UT to Town Creek Restoration Project – Option A Year 7 Monitoring Report/Closeout Report

DMS Project ID Number – 94648; NC DEQ Contract No. 003277

Subject: Response to DMS Comments for MY7 Draft Report
UT to Town Creek Mitigation Site, Stanly County
DMS Project #94648, DEQ Contract #3277

DMS MY7/Closeout Draft Report Comments:

**Figure 2 Overview
Current Condition Plan View**

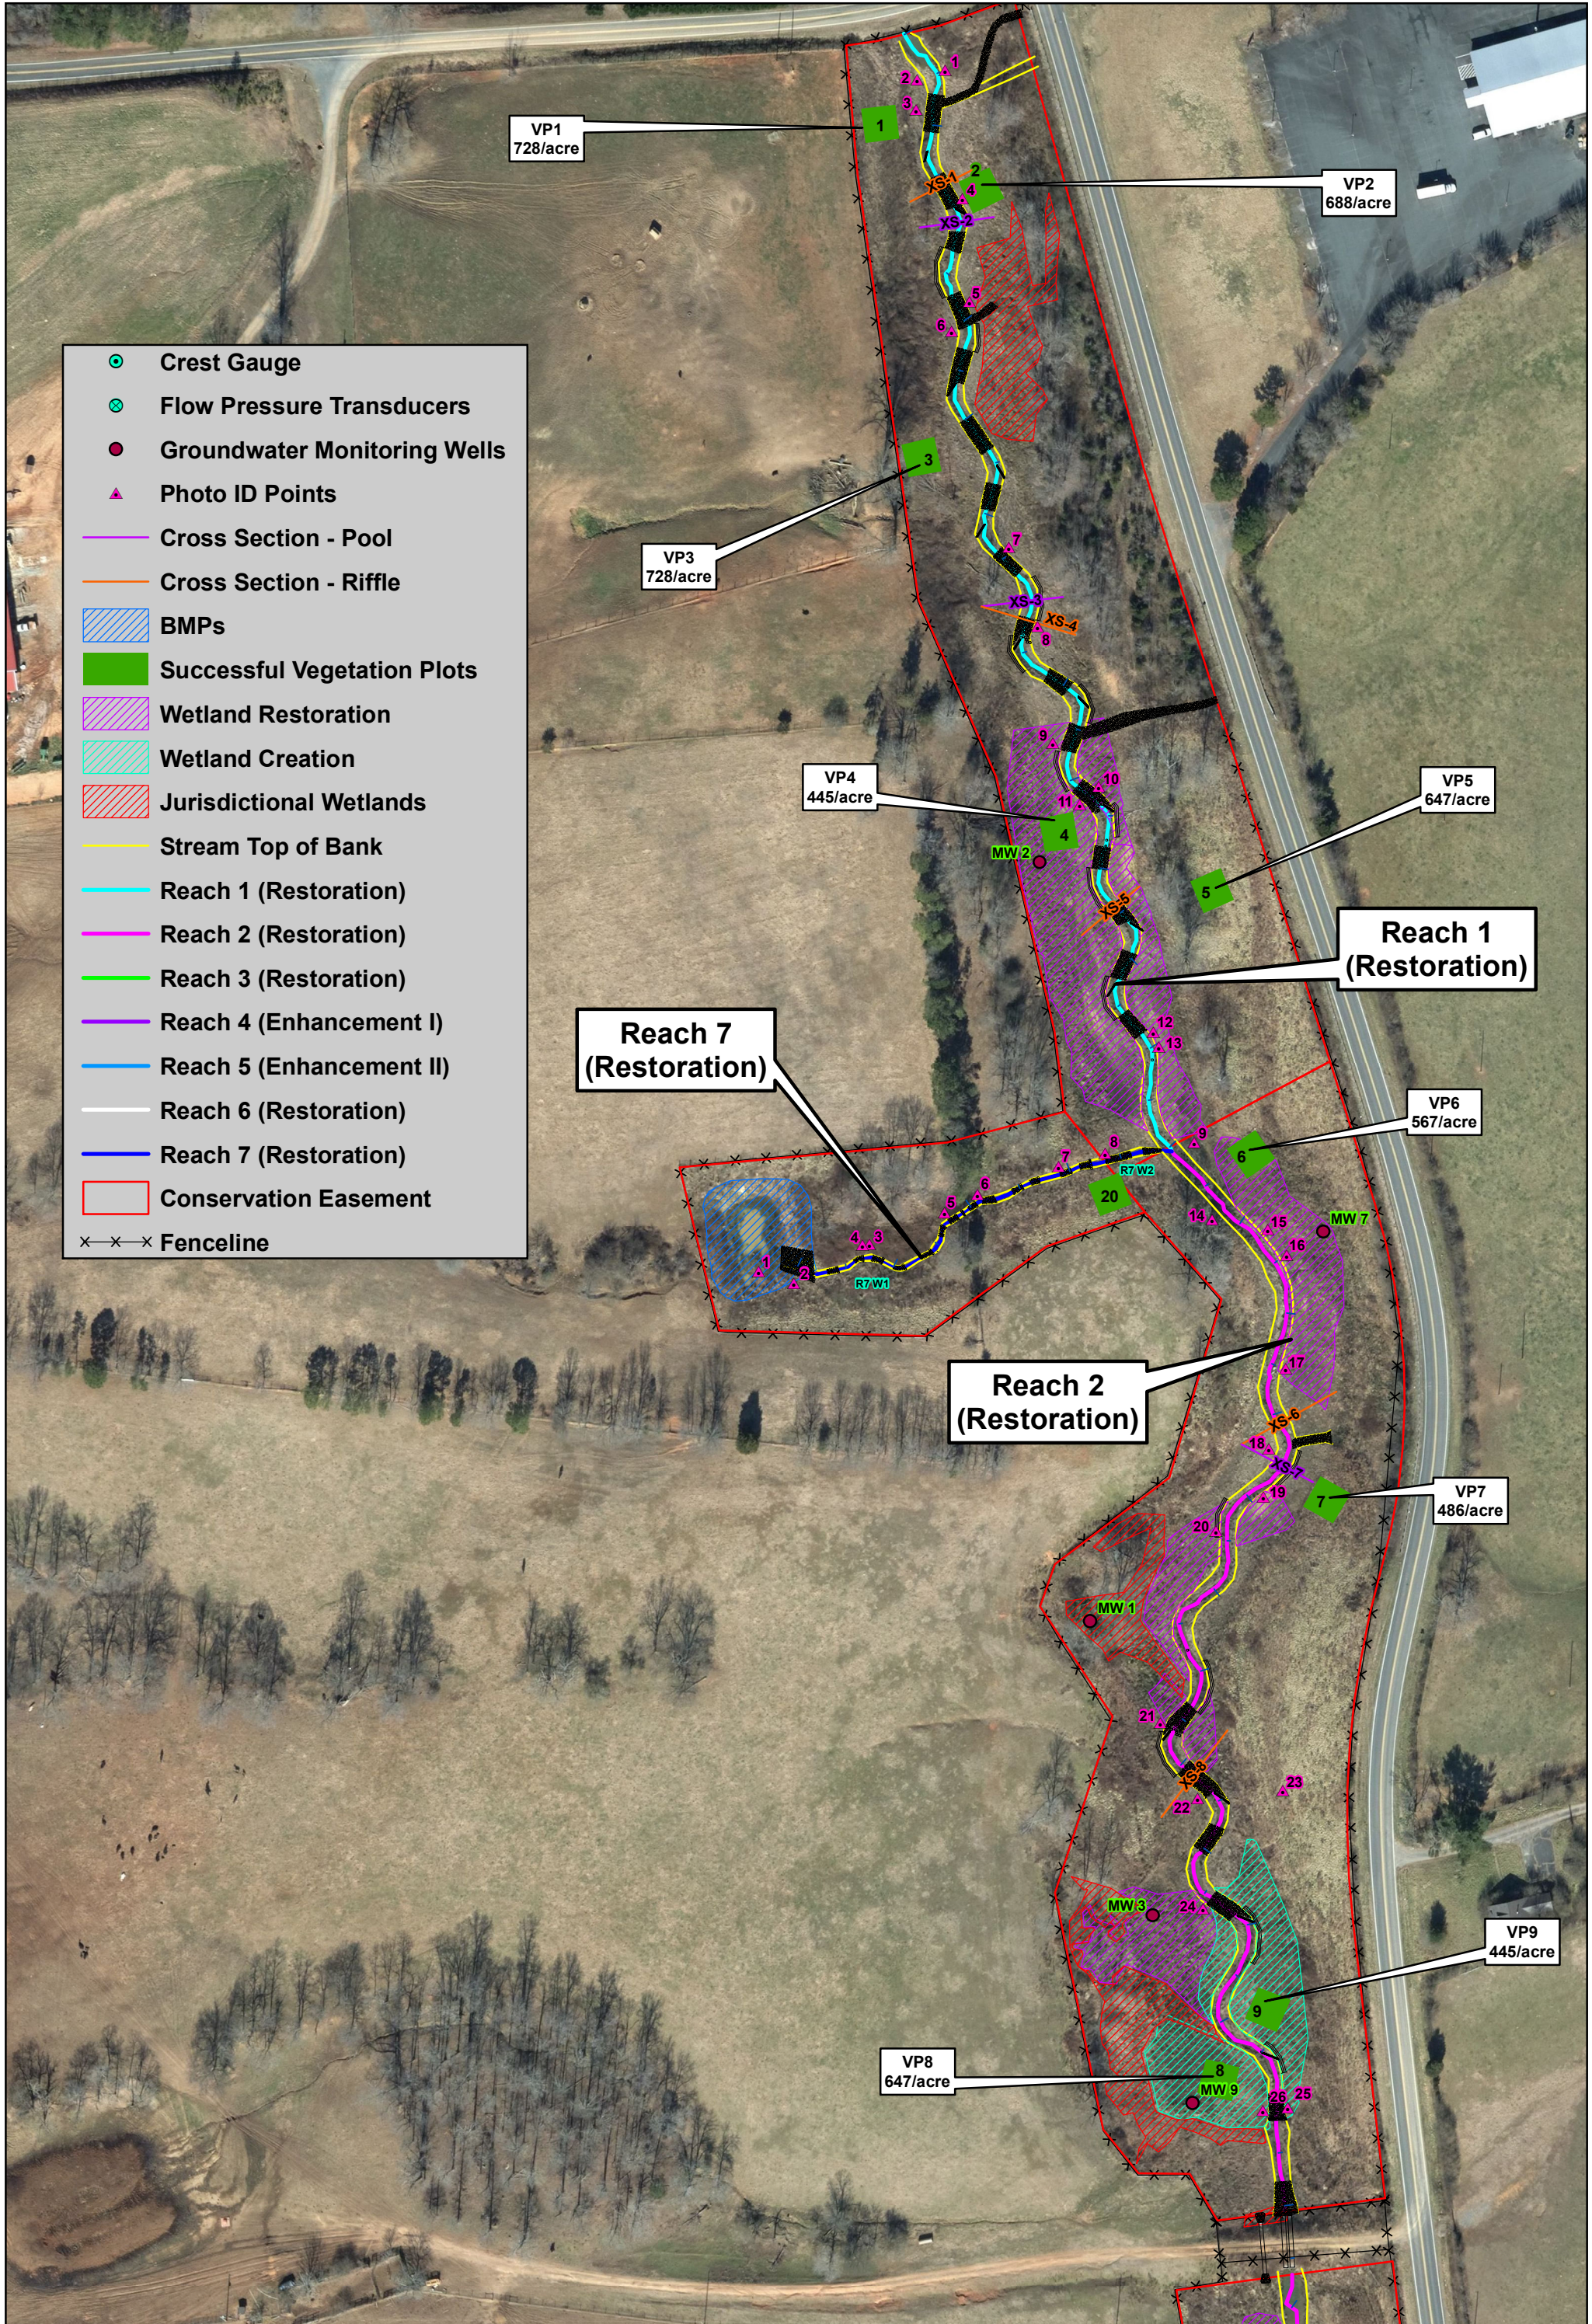
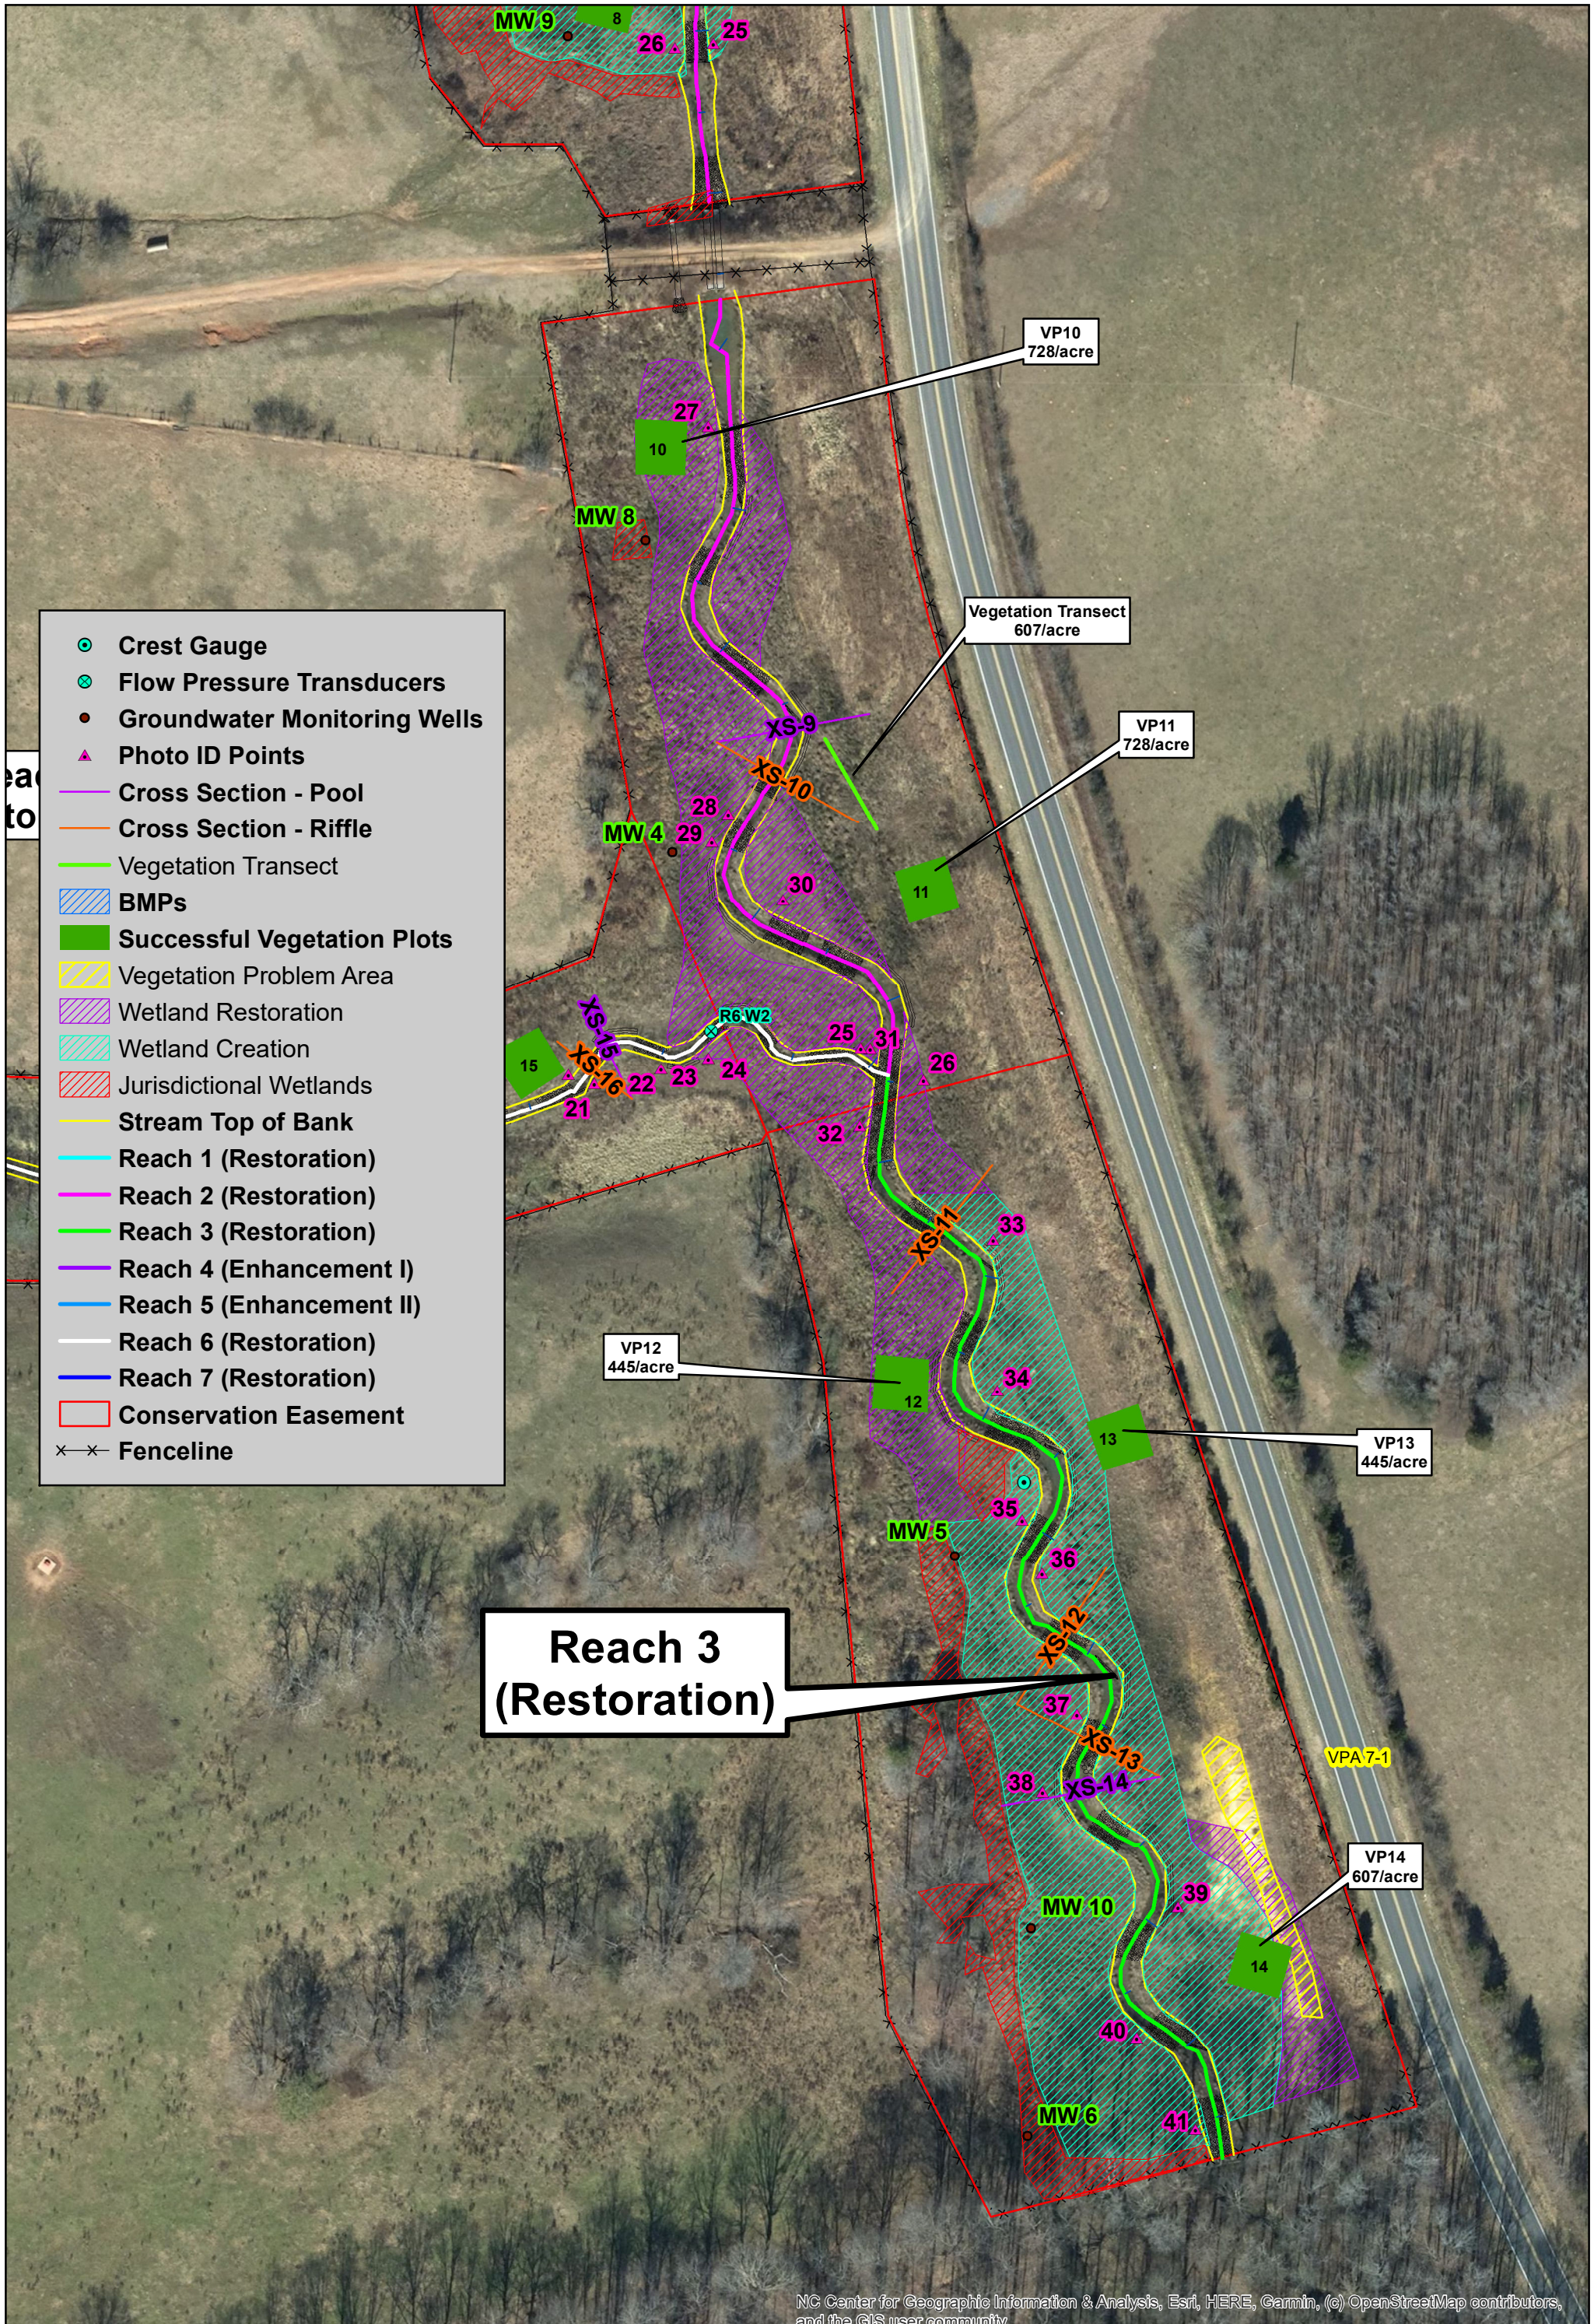
- The CCPV in the report is incomplete, it appears there should be a figure 3 to include the monitoring stations on reach 6 as there are vegetation plots on that reach.
Response: Wetland credits and monitoring features within these credited areas are located on reaches 1,2 and 3. Therefore, reach 6 was not included in the figure 2 CCPV.
- The vegetation data is incomplete; the submission included 14 plots, CCPV indicates greater than 20 vegetation plots. The meeting minutes from 2021 also indicate transect data for creation area added; please submit the data. Suggest that this data is presented in greater detail in the report (species list with density).
Response: Michael Baker has added vegetation transect data to table 9 found in Appendix C.

- The photo point data is incomplete; the CCPV indicates a minimum of 41 photo points not included in the digital data submission.
Response: Not required per June 2021 IRT site meeting.
- Suggest clarifying on the CCPV that the 'jurisdictional wetlands' are wetlands that were delineated post project and not for credit.
Response: Revision have been made as requested.
